SITE PLAN - LANDSCAPE PHASE 1

S2112 Response:

SITE PLAN - PROPOSED SOIL DEPTHS

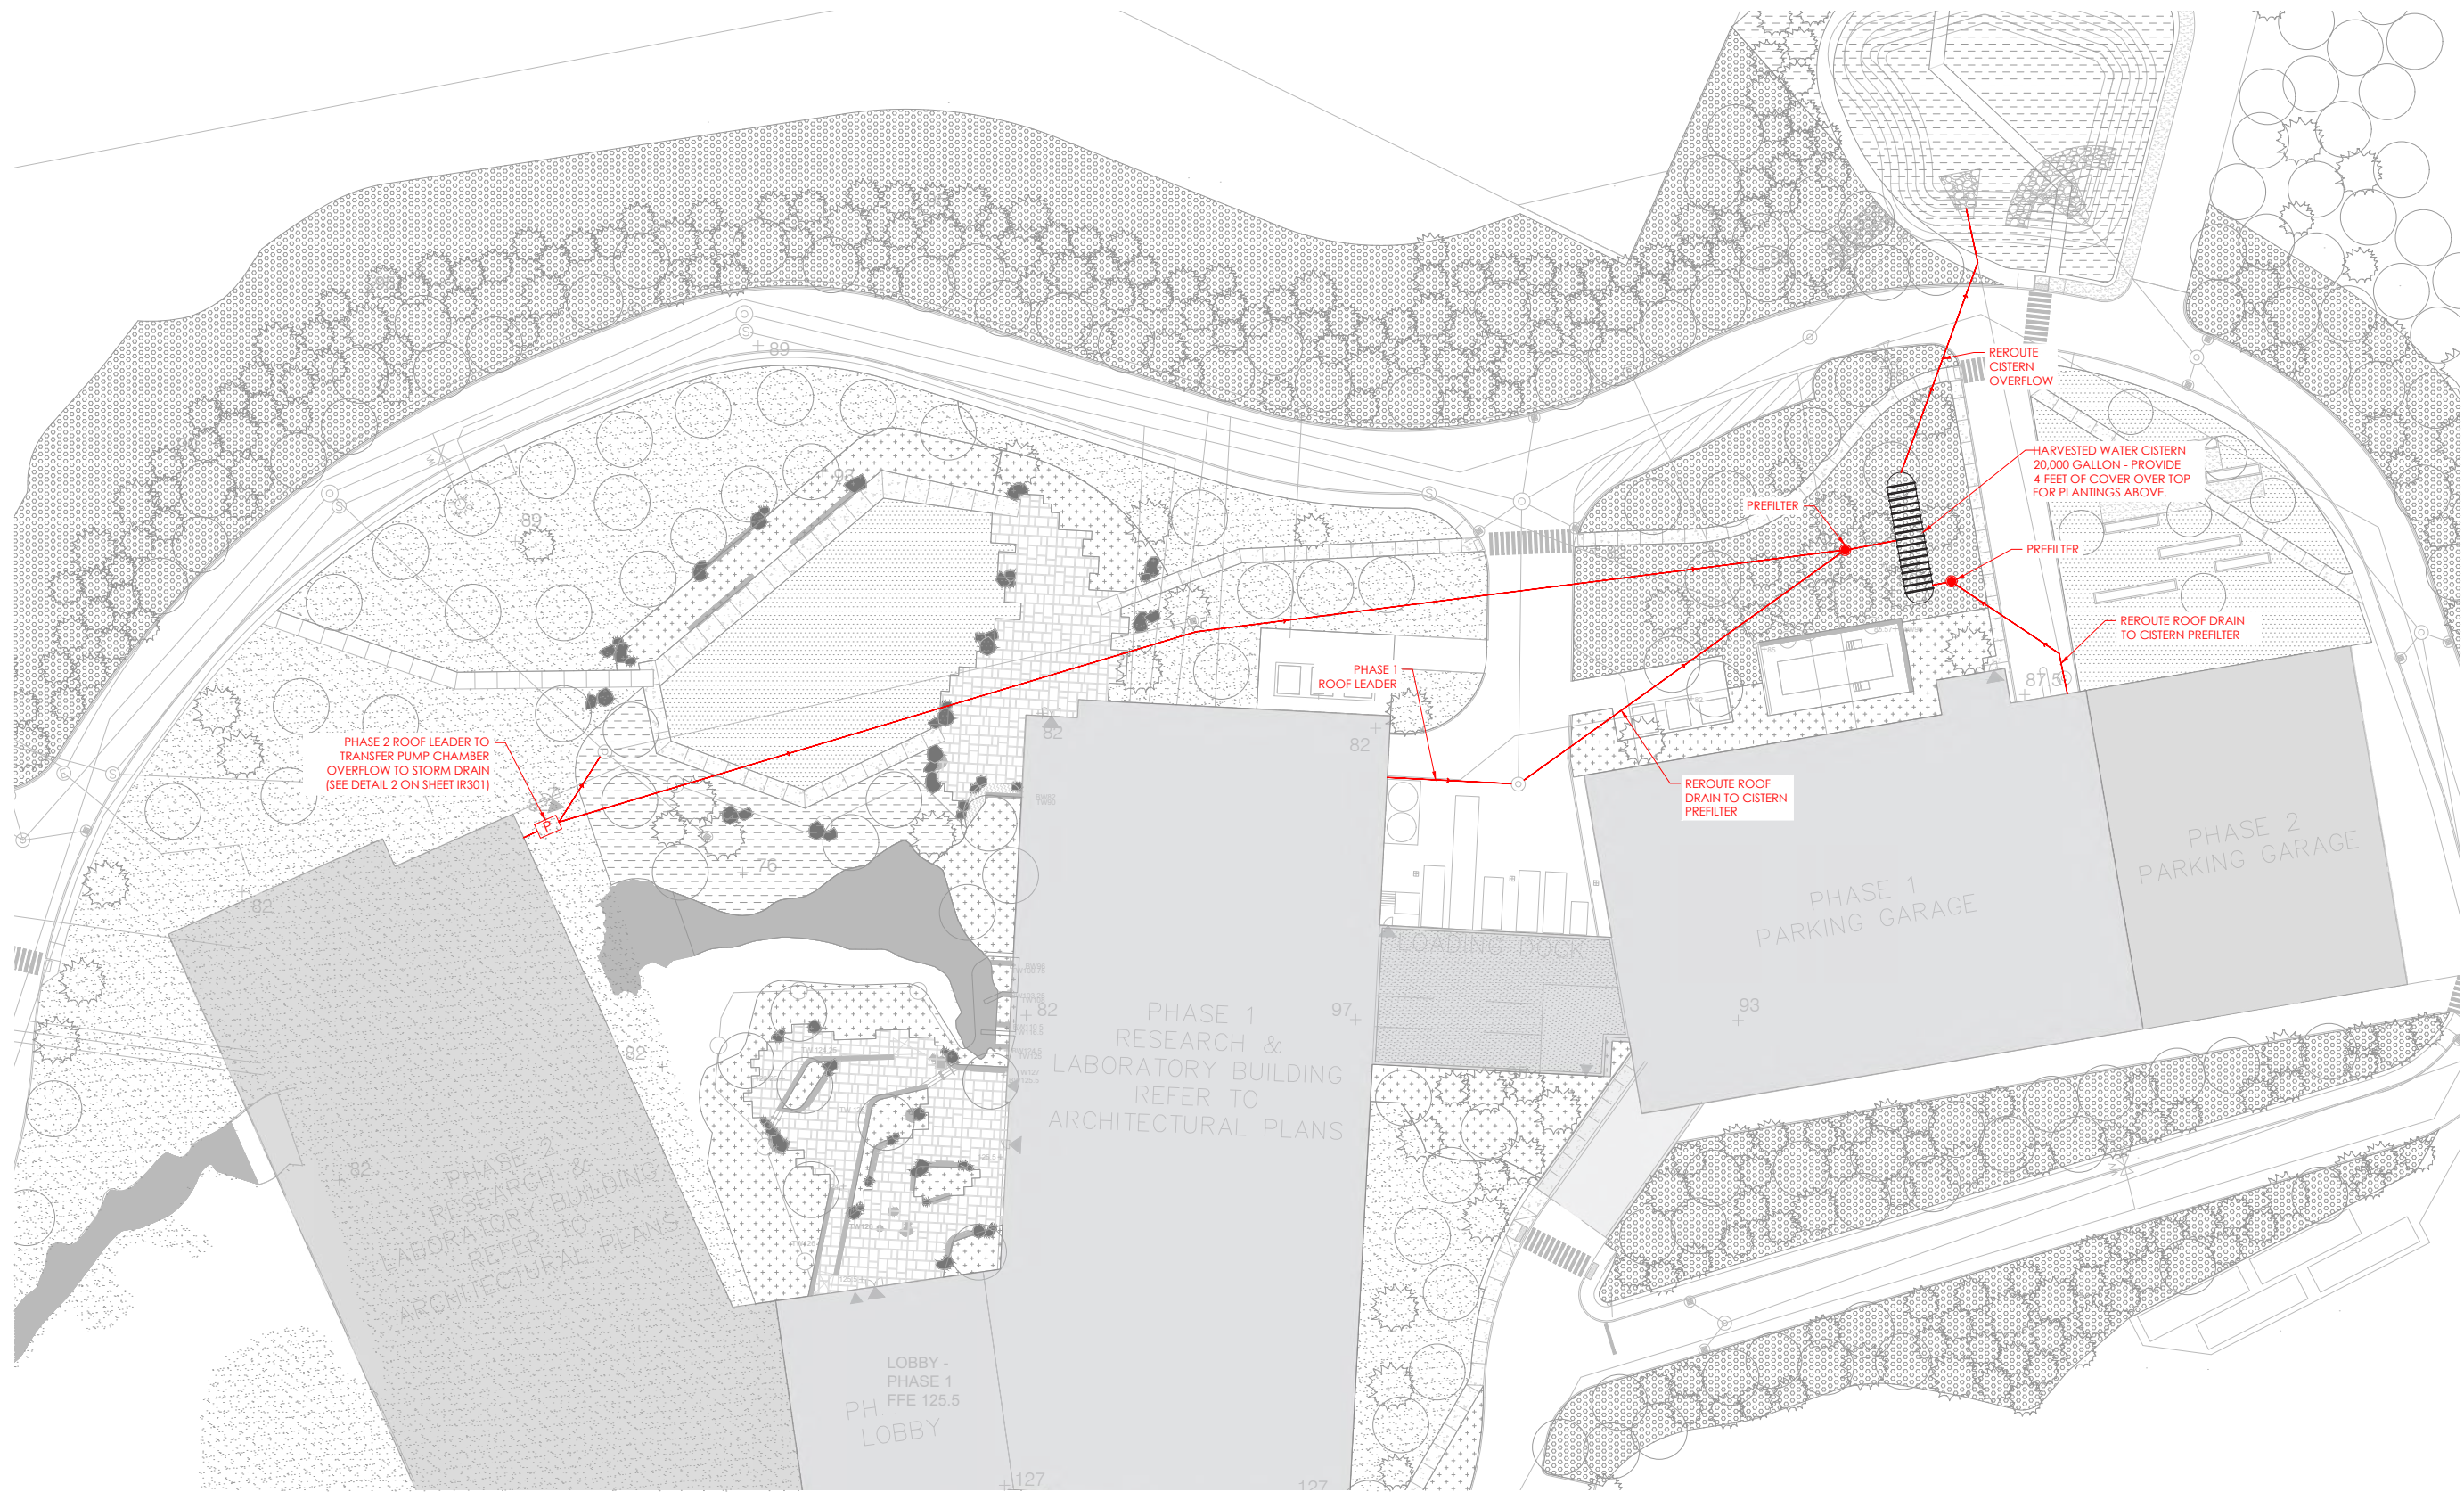
ADDRESSING THE 4” SOIL DEPTH IN SEEDING AREAS TO THE NORTHEAST

Where planting is meant to be permanently established, in close proximity to the building and an integral part of the campus a minimum 6” of soil is provided for long term enhancement of the landscape.

In comparison 4” of soil is only suggested in a large area to the north east of the building and loop road – this is not part of the current Phase 1+2 project but is currently stripped land used for quarry activities. Soil and seeding is proposed to prevent erosion and provide a temporary cost effective solution as that area may be developed in future phases. Due to the large square footage of the area increasing soil depth is cost-prohibitive and the design team is confident that with 4” of soil and a native, erosion control seeding that the area will be improved.

UTILITY SCREENING AT GARAGE - SECTION

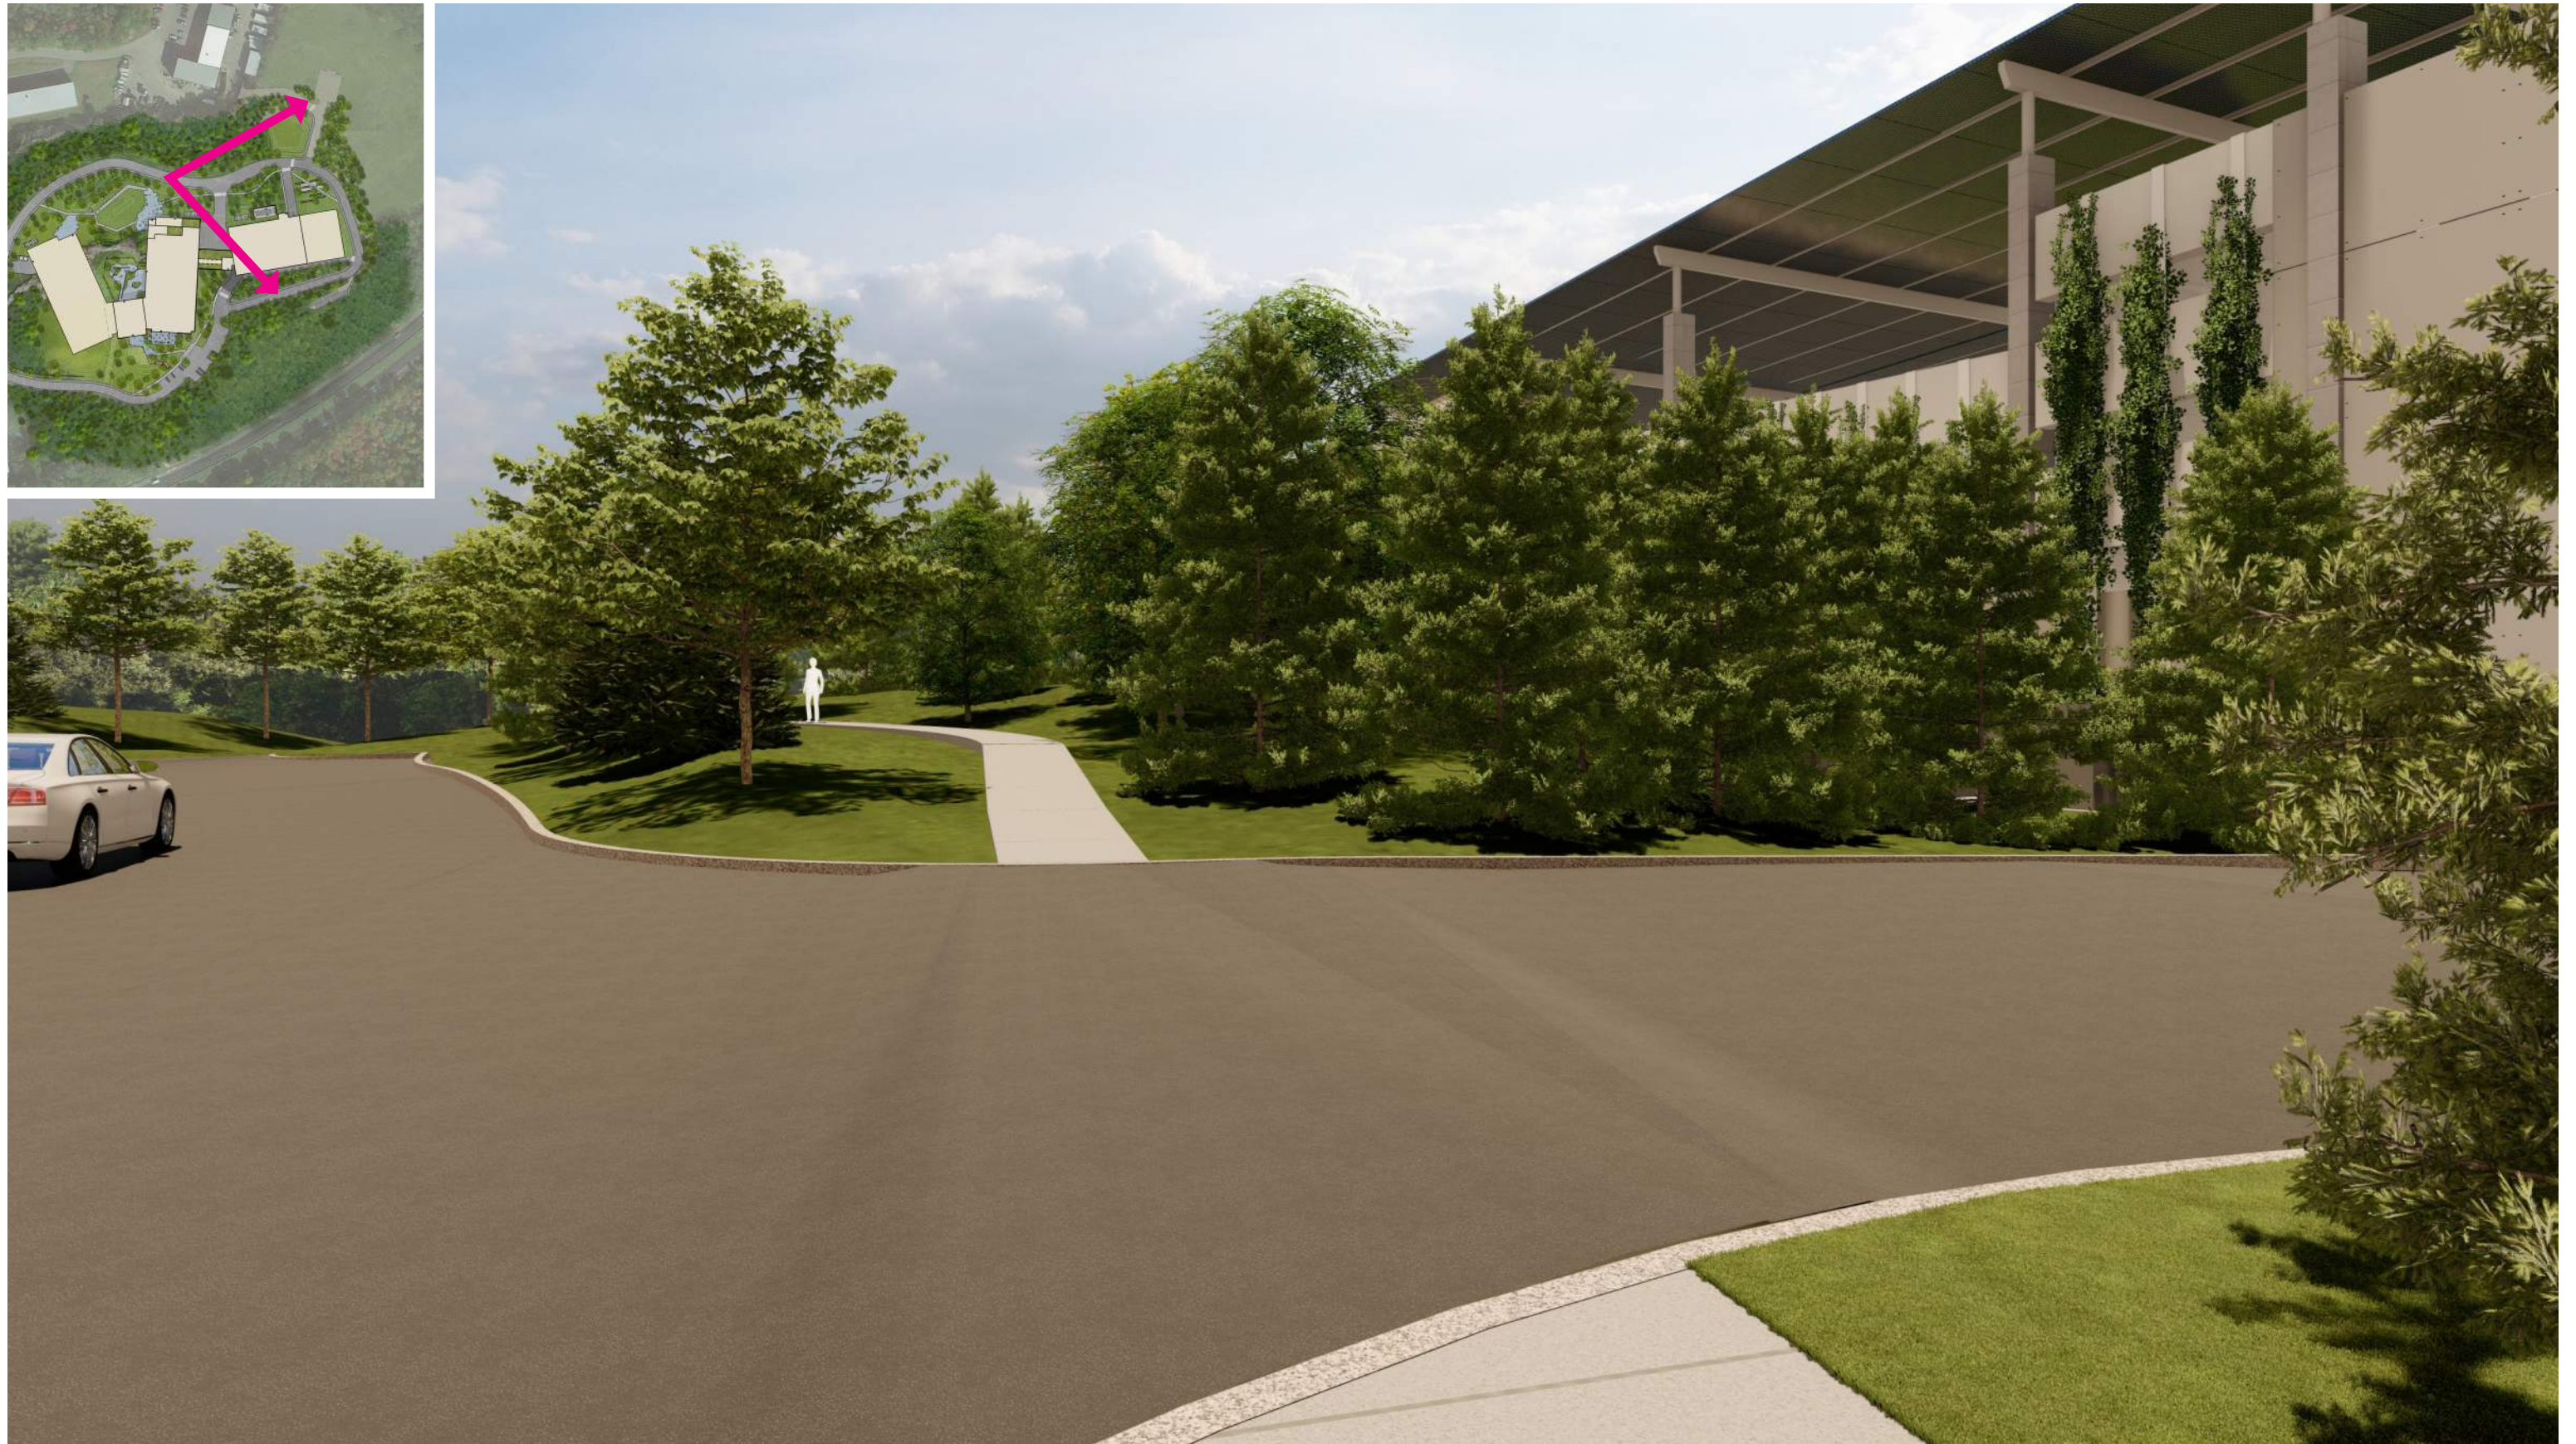
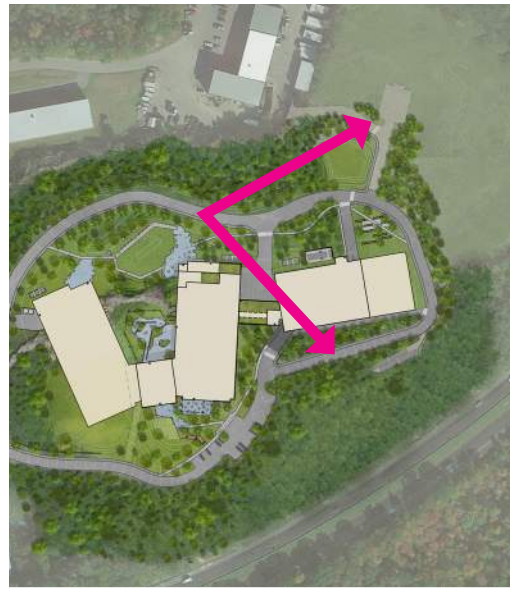
FENCING FOR GENERATOR SCREENING:

S2112 Response: Proposed 8' tall louvered fencing on top of retaining wall at generator and garage to provide safety and screening in addition to plant material as previously shown.

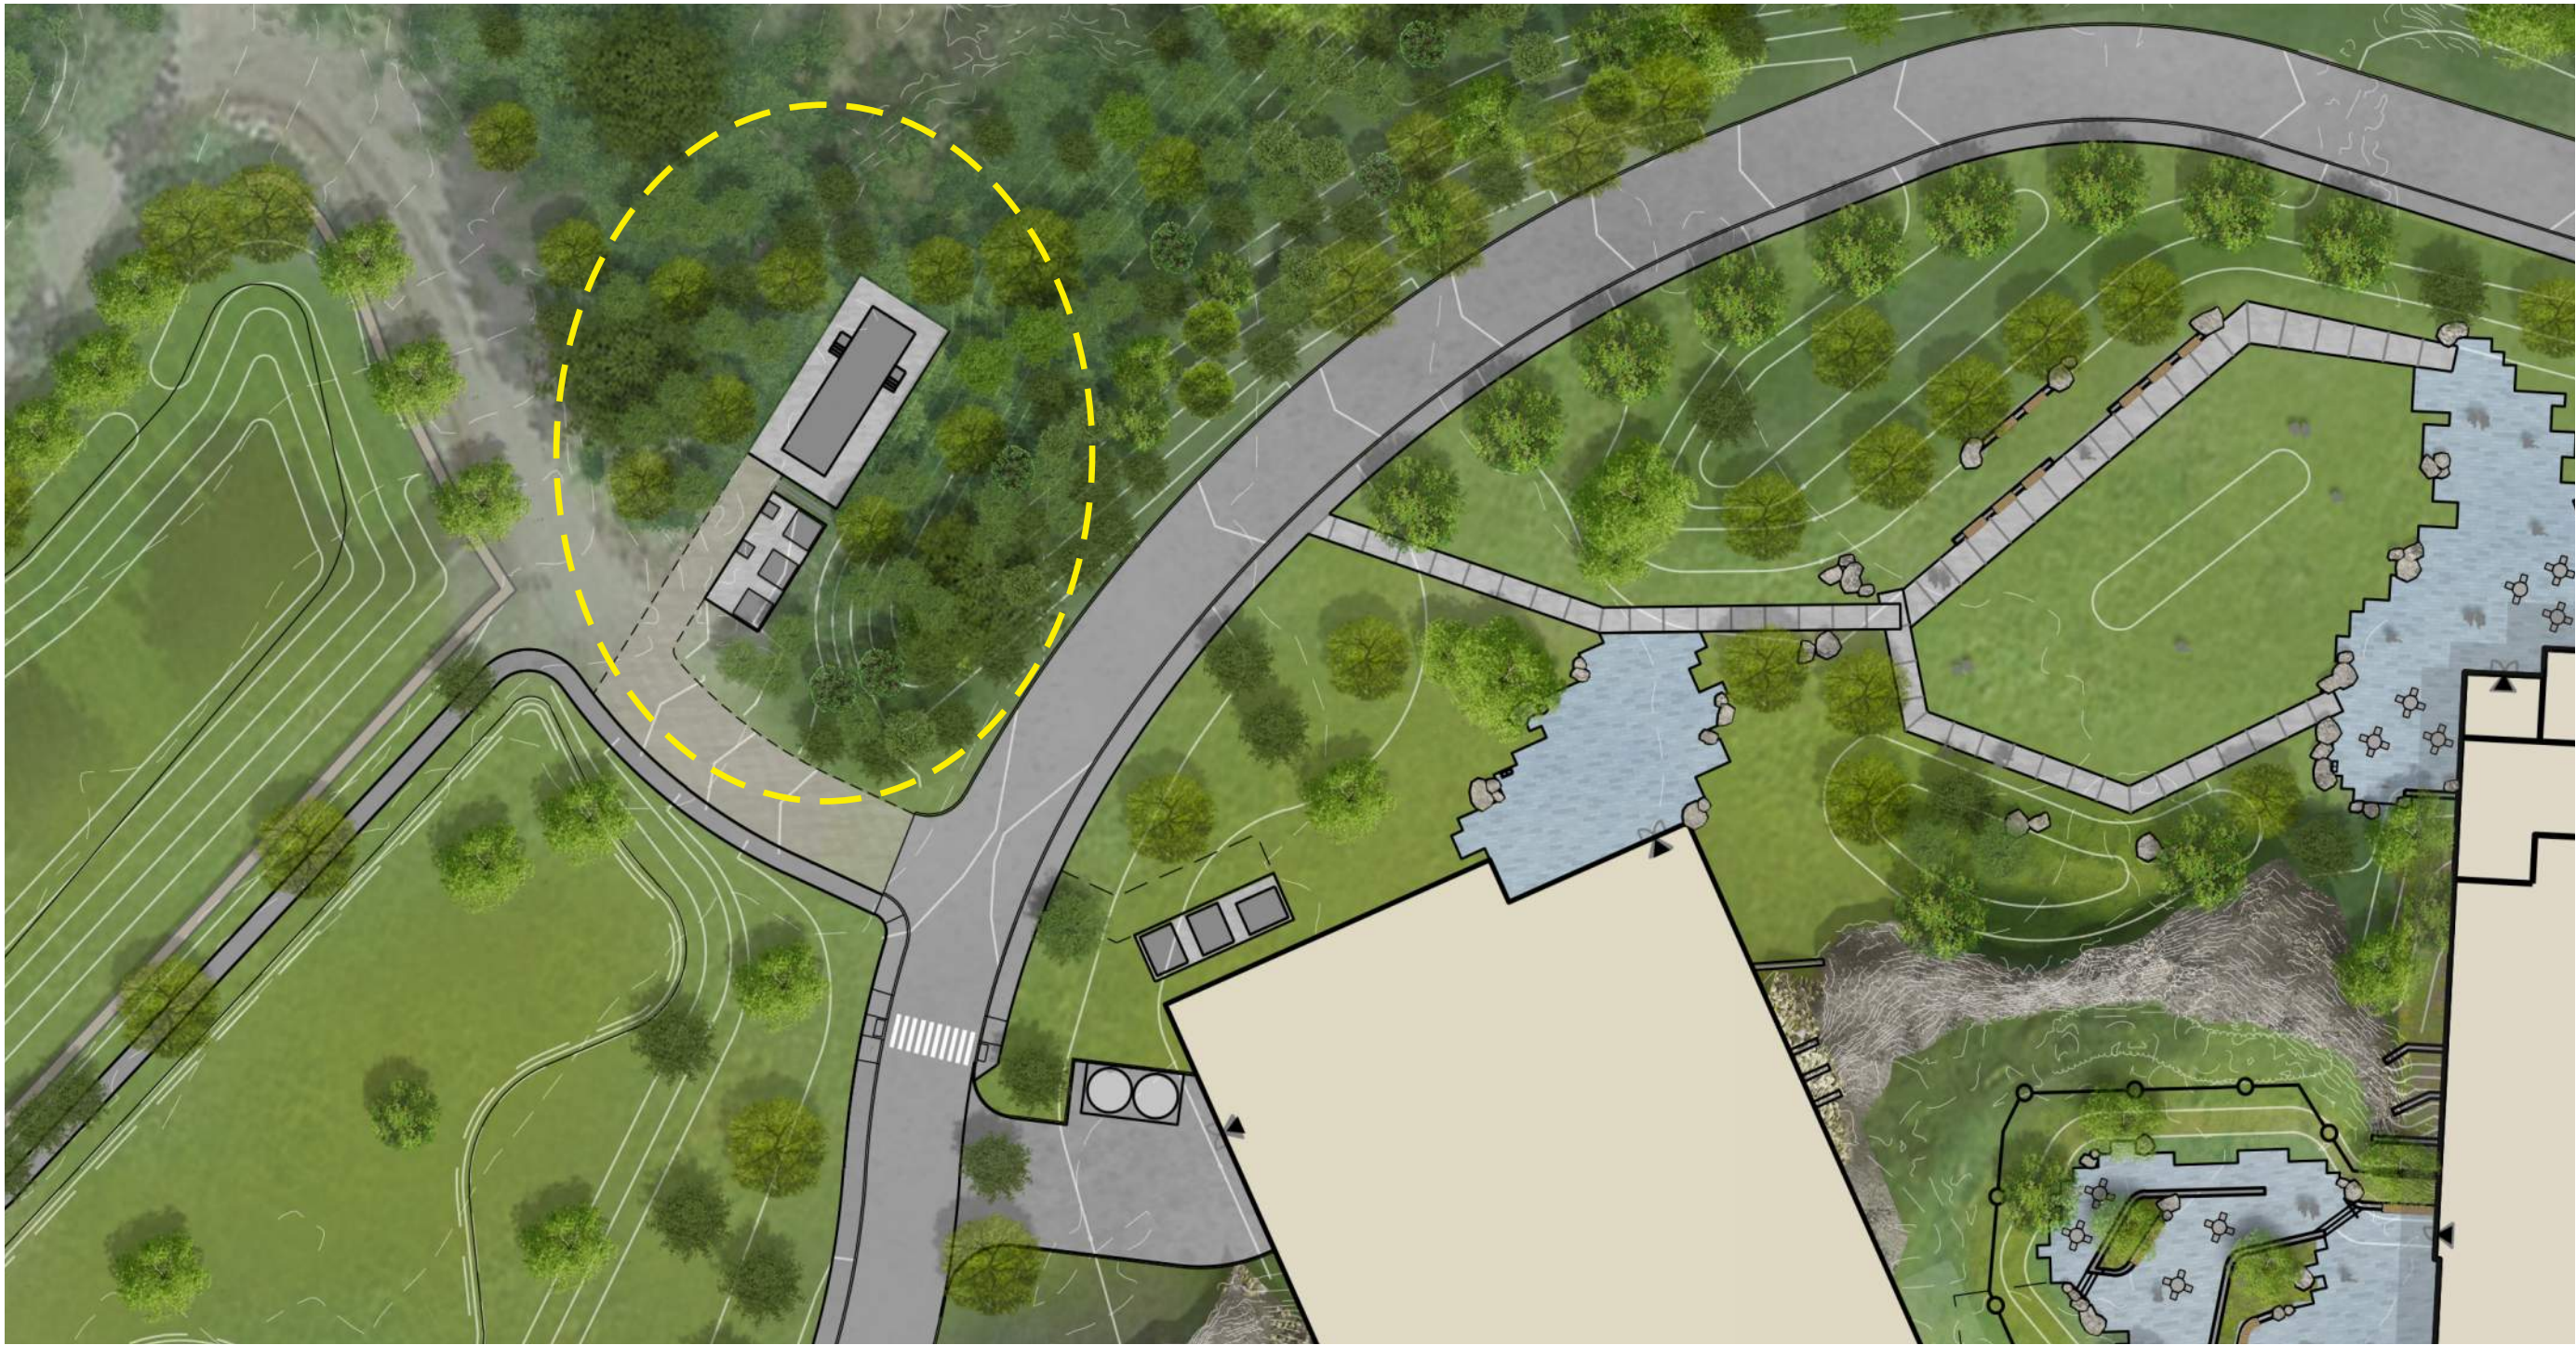
SECTION 7.6 UNSIGHTLY USES AND AREAS:

S2112 Response: Existing vegetation will remain north of the phase 2 generator to provide screening in that direction. South-east of the generator the design proposes a heavily planted berm to shield views of the generator and electrical equipment from the building and road. Additional planting will be provided to the north if required.
